| 8802-3/802.3 REVISION REQUEST 1166 |

REQUESTED REVISION:  
STANDARD: IEEE Std. 802.3af-2003  
CLAUSE NUMBER: 33C.16  
CLAUSE TITLE:

Figure 33C.16:

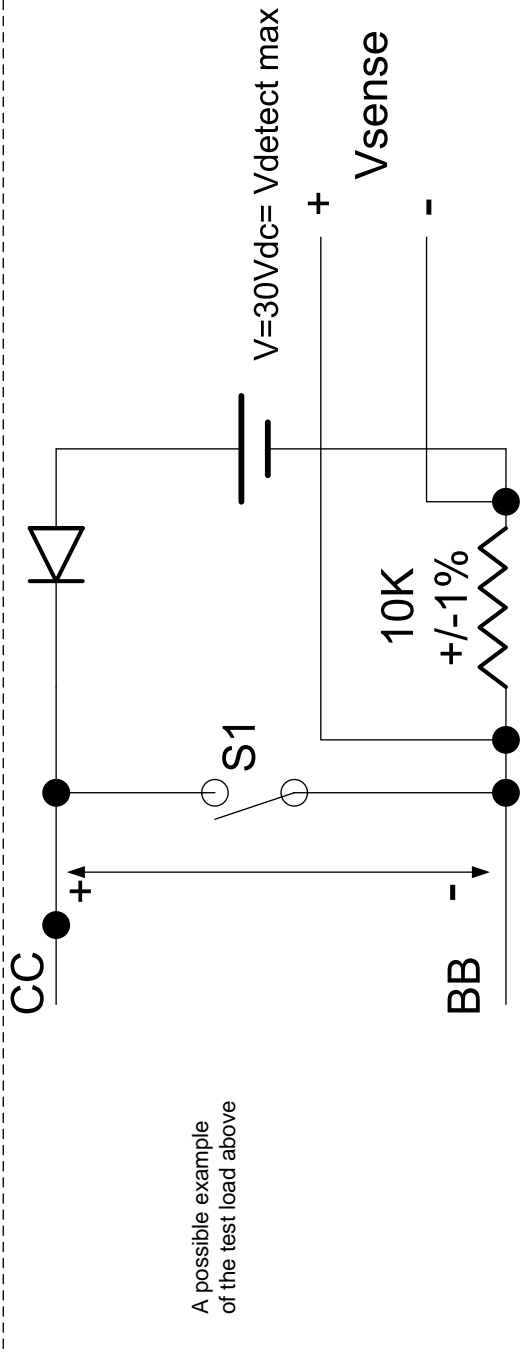
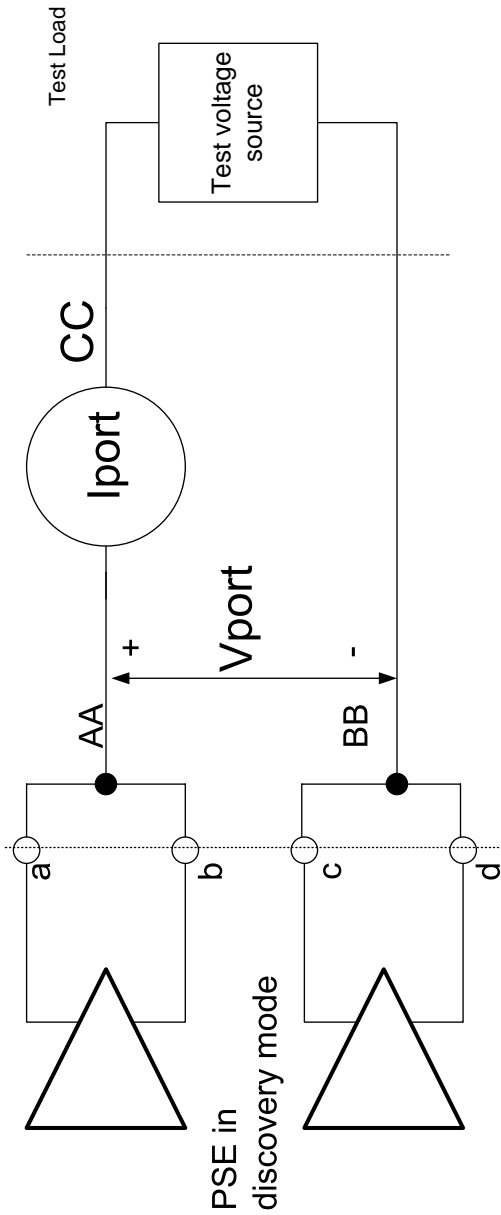
Replace the 30V source and S1 at the upper part of figure 33C.16 with a block labeled test voltage source. Delete the label test load.

The test setup as described in figure 33C.16 and test procedure PSE-14 is designed to measure Rrev which is the Zsource of the detection circuit as specified by figure 33-8 and 33-9, measured from the outside into the port. (That's why it was labeled as Rrev in Table 33-6 item 2b).

If there are other elements across the port, the result of Vsense in the example test setup will be changed and needs to be accounted for by the test setup.
